Libbytown Traffic and Circulation Study Public Advisory Committee Meeting

April, 22th 2013
Portland Expo Center

Figure 1: Ramp labels

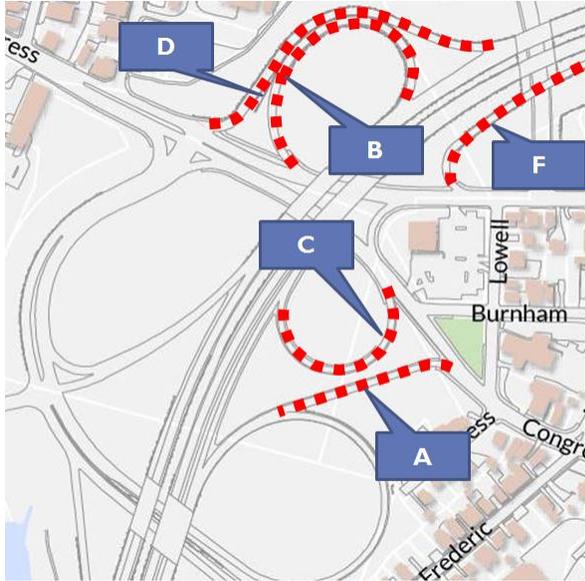
The original eight alternatives were screened through traffic prediction models and the input from the meetings. MDOT was concerned about the costs of constructing new ramps so all alternatives including new ramps were removed. Ramp D (see Figure 1) was determined to have safety concerns and to be easily replaced by diverting traffic to Fore River Parkway exit so all alternatives that kept Ramp D were removed.

Figure 2: Alternative 1A

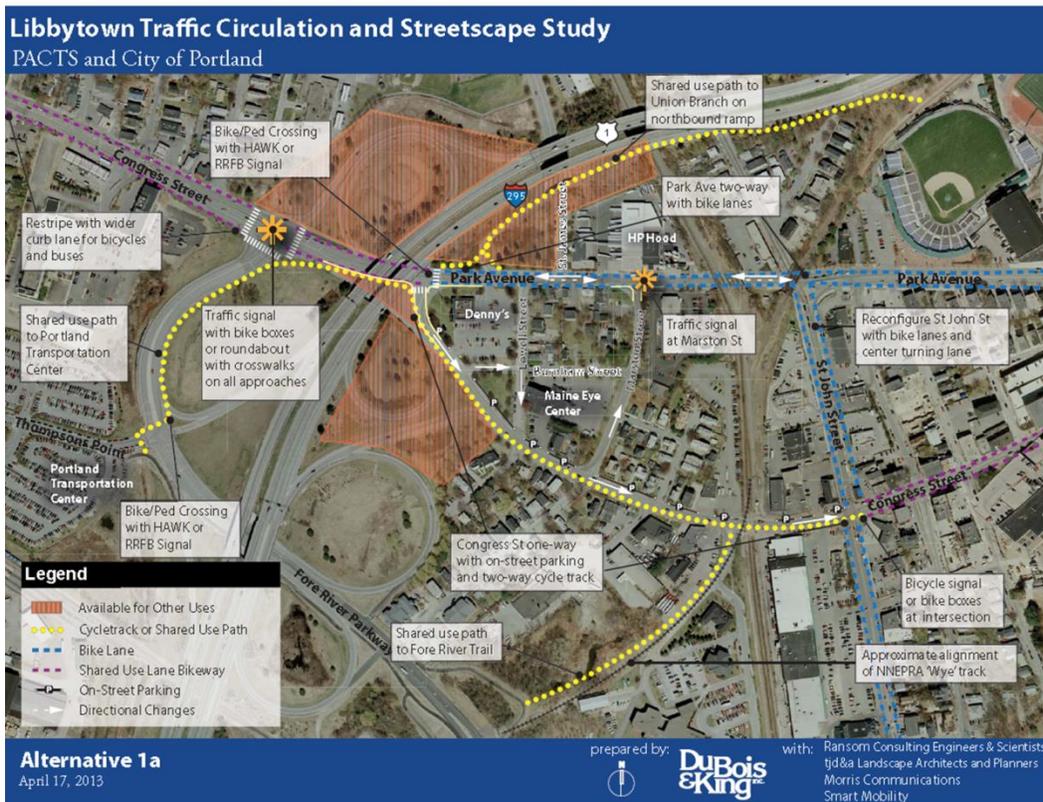
A committee member noted that they liked alternative 1A but would like to see parking on both sides of Inner Congress instead of just on one. They also liked the two way cycle tracks having used them in other places. Cycle tracks would be particularly good on Inner Congress if it were one way to allow counter flow bike traffic. They felt that keeping the Ramp F would be unnecessary if Congress was two way.
